ADDENDUM

STATE OF CONNECTICUT
UNIVERSITY OF CONNECTICUT HEALTH CENTER
Procurement Operations & Contracts
263 Farmington Avenue, MC4036
Farmington, CT 06032-4036

FOR: The University of Connecticut Health Center

Diagnostic Dental X-Ray Equipment
Compliance Survey and
Shielding Evaluation Floor Plan

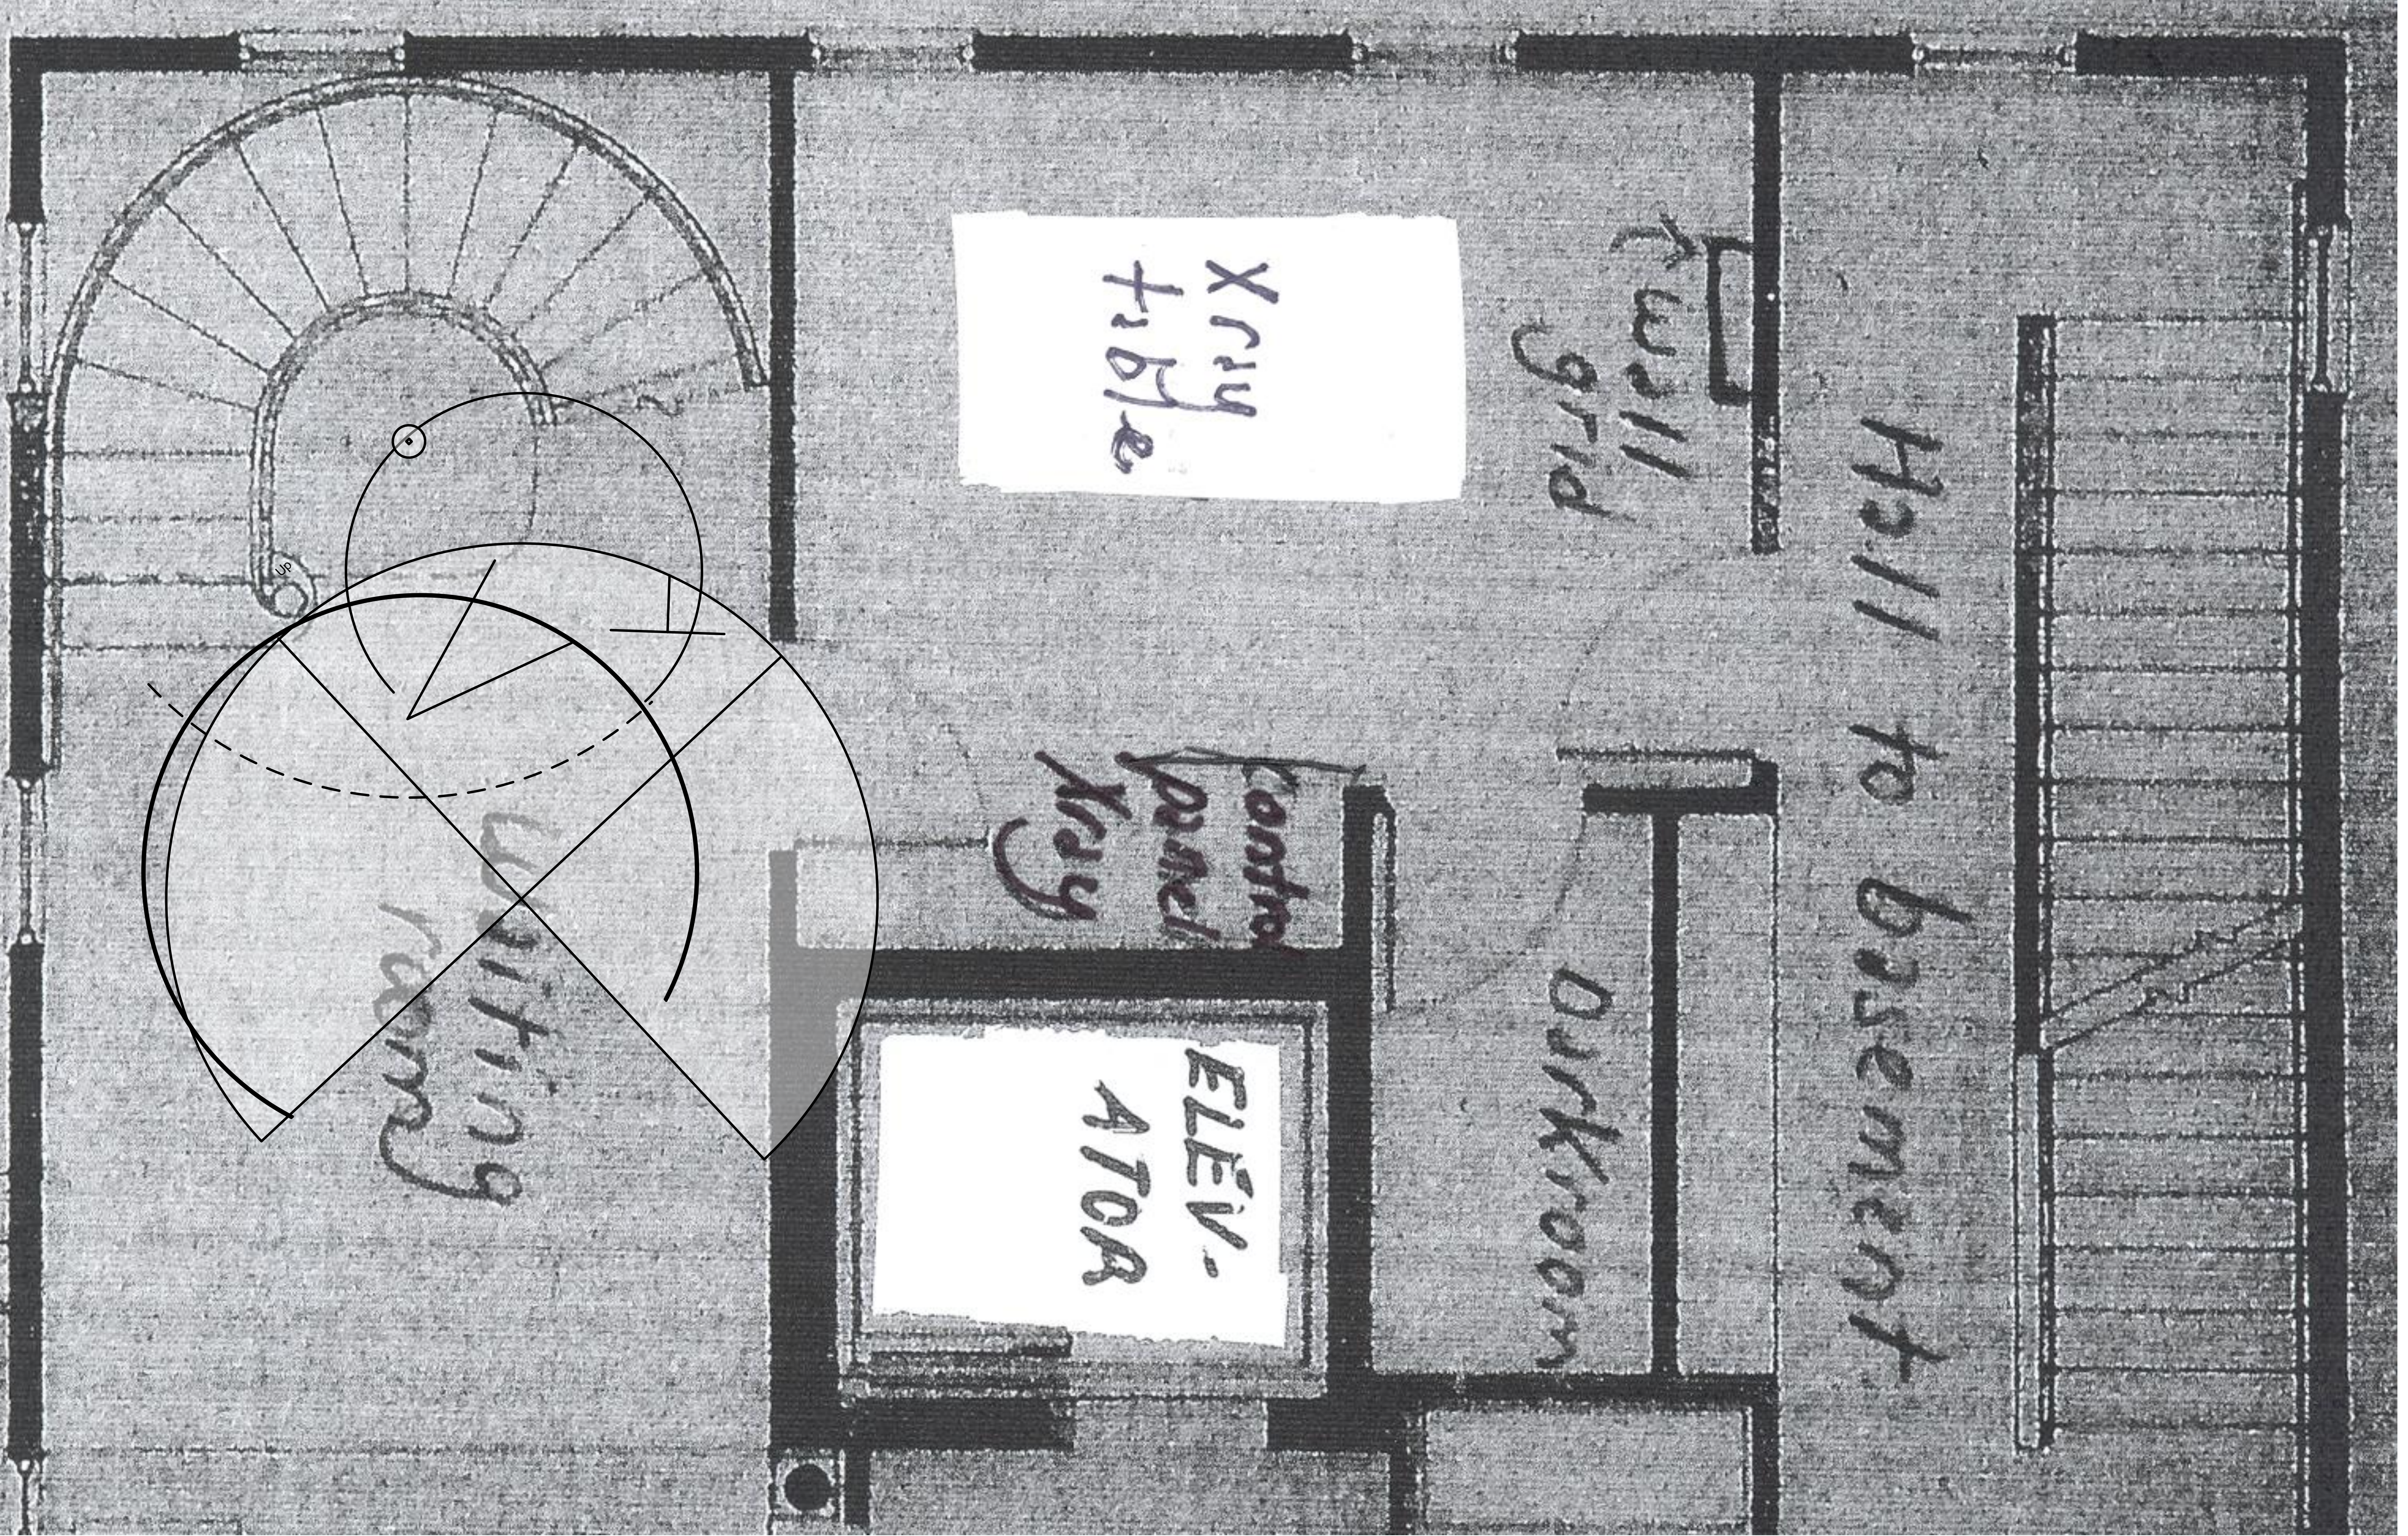
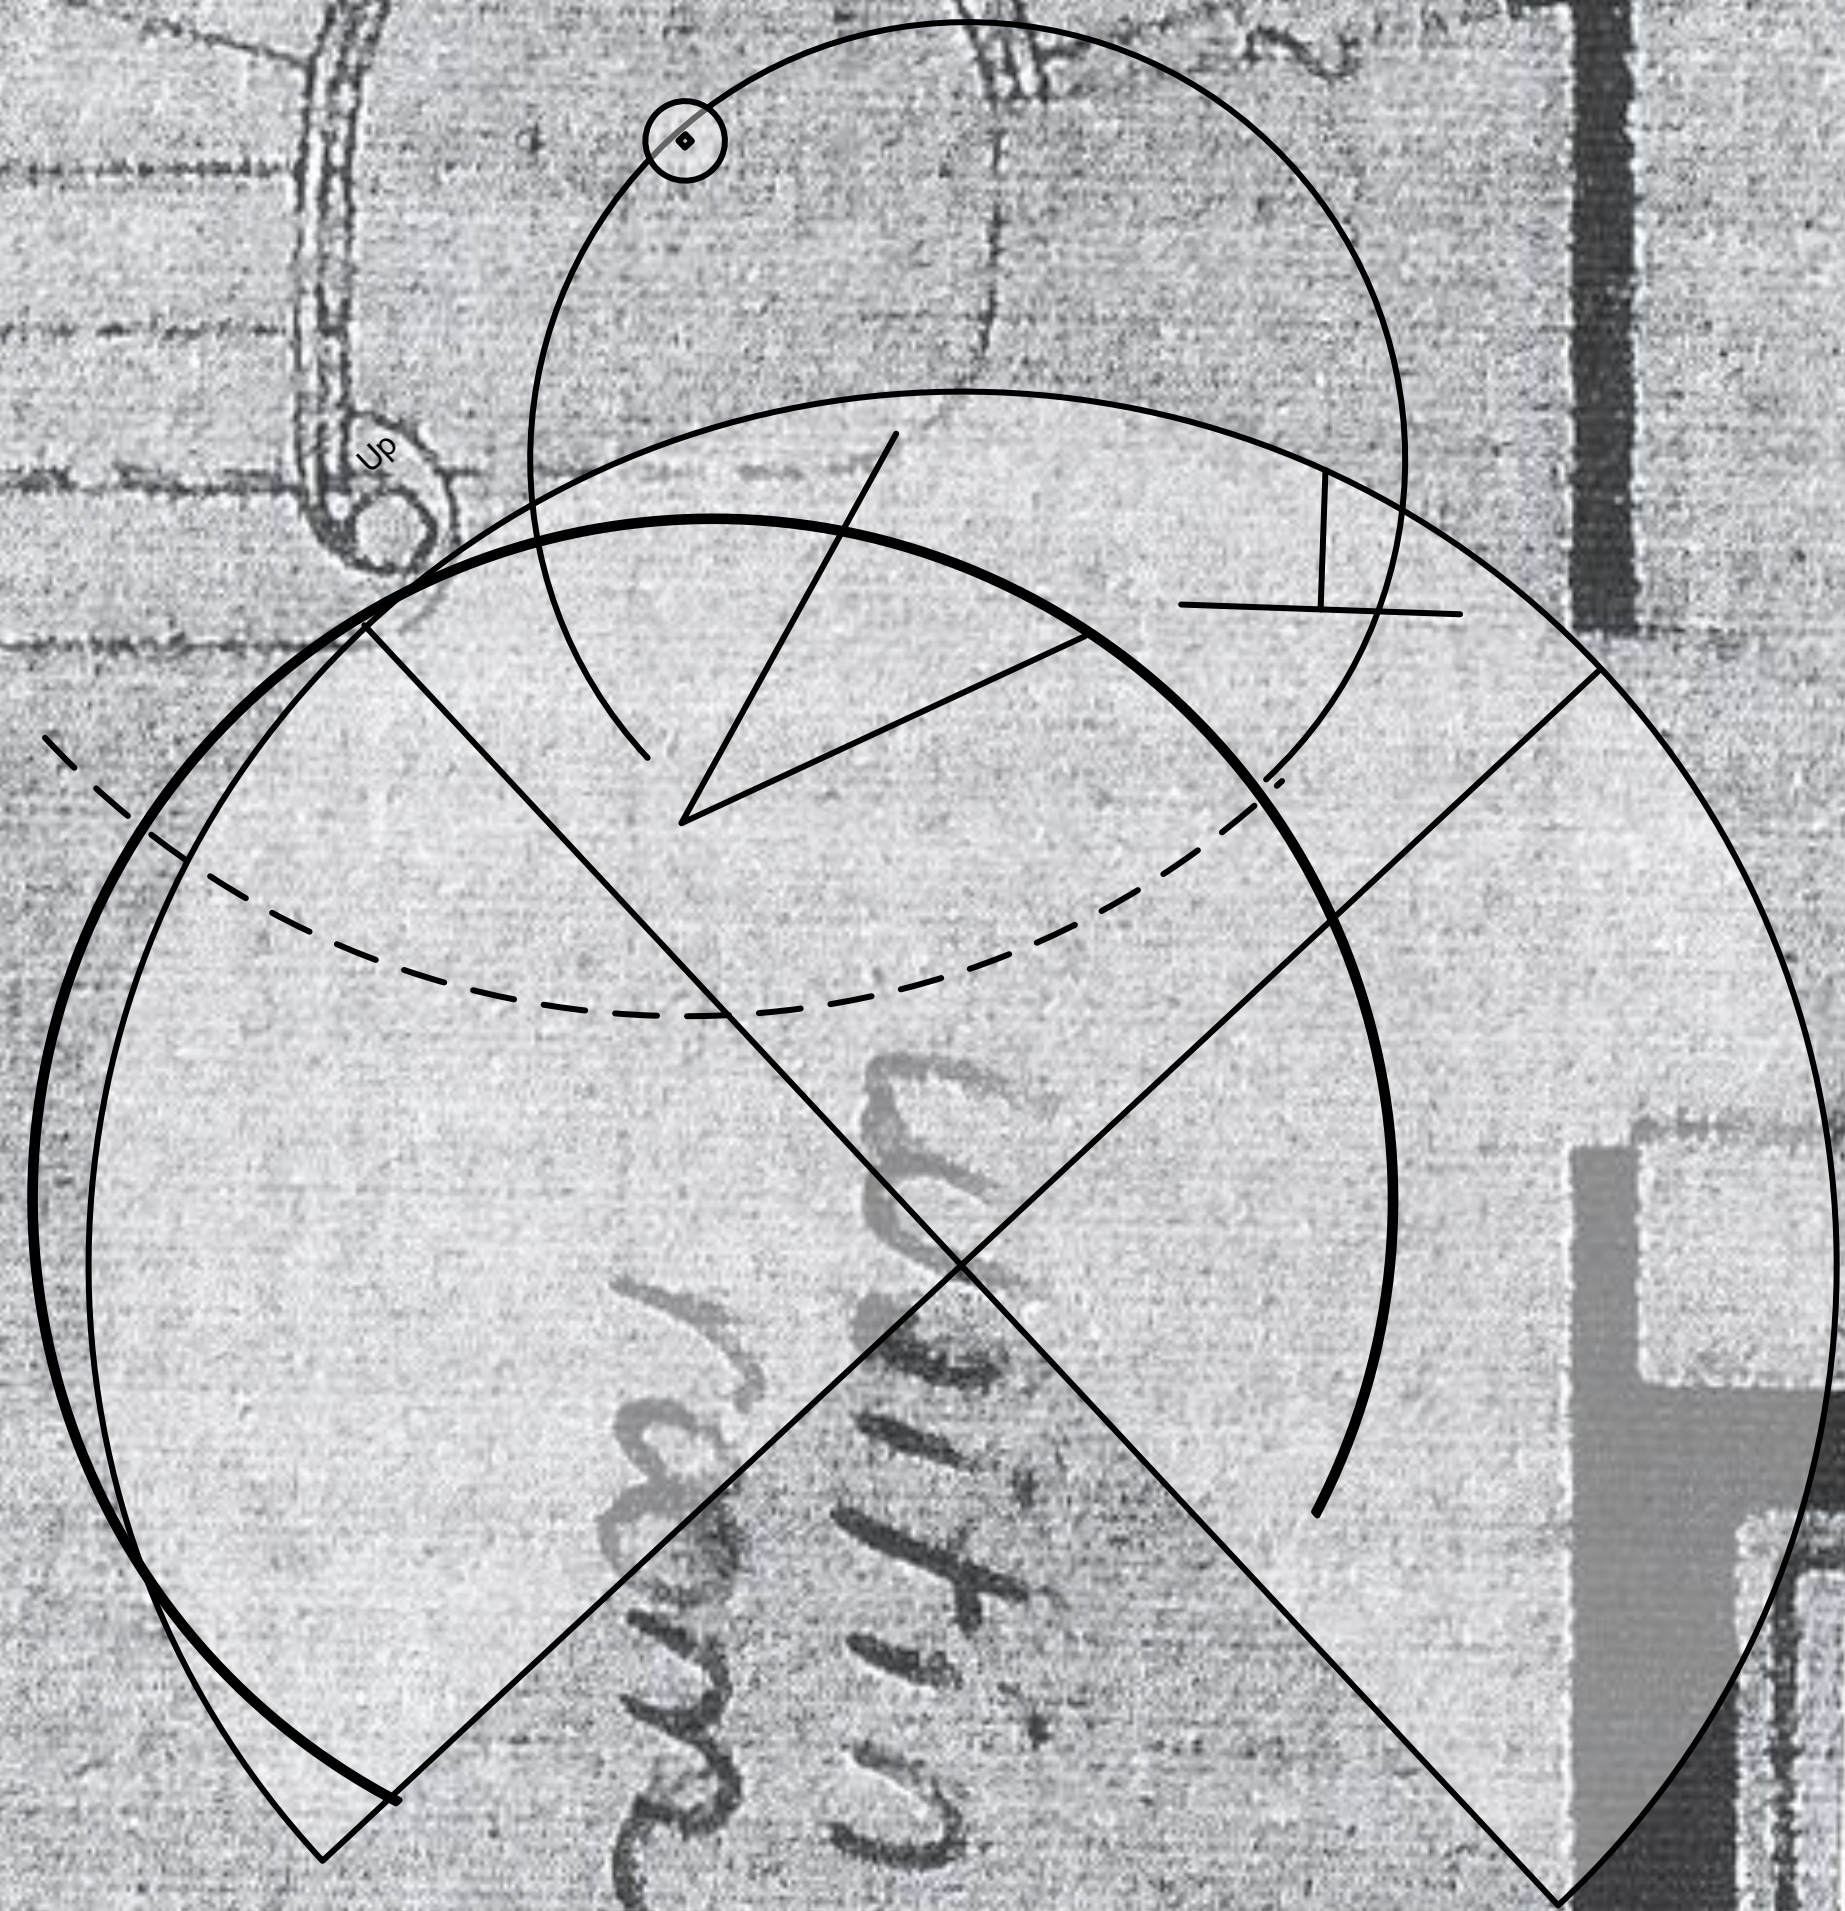
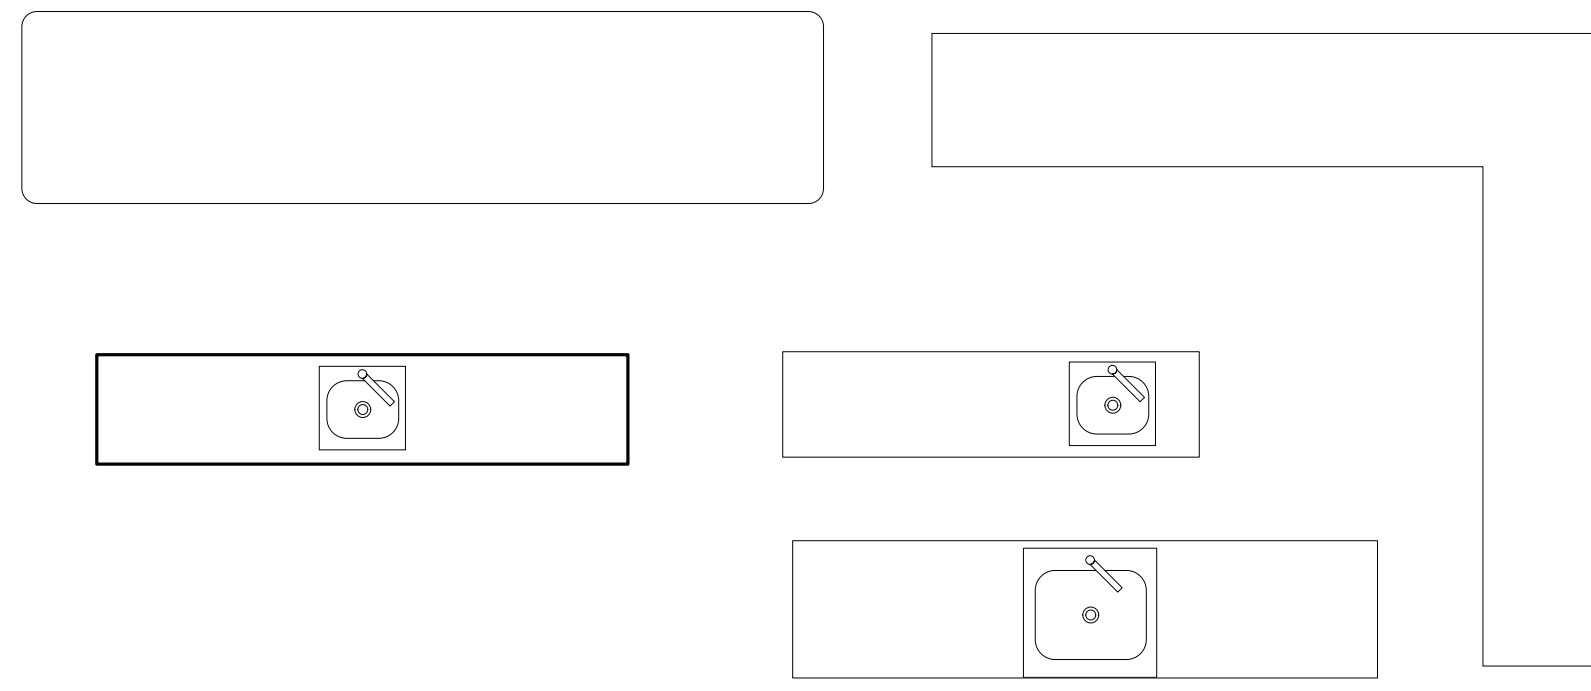
Attached is a diagram that shows the location of the x-ray unit in the X-Ray room and the areas surrounding this room.
